Application No. 10/629,408
Amendment dated February 1, 2005
Reply to Office Action of September 21, 2004

REMARKS

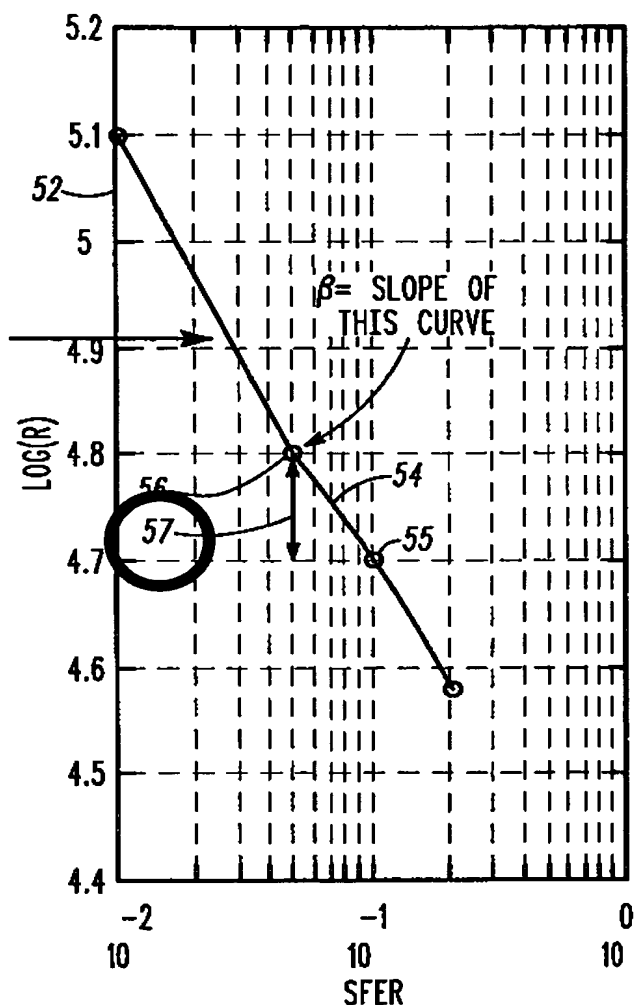
The Examiner has objected to FIG. 5 under 35 C.F.R. § 1.84(p) (5) as failing to include reference numeral 57 as is mentioned in the description. The applicant respectfully submits, however, that reference numeral 57 is, indeed, already present in the figure. A relevant portion of FIG. 5 is presented below wherein reference numeral 57 is circled to aid in its identification. The applicant respectfully submits that FIG. 5 is in suitable condition to support allowance.
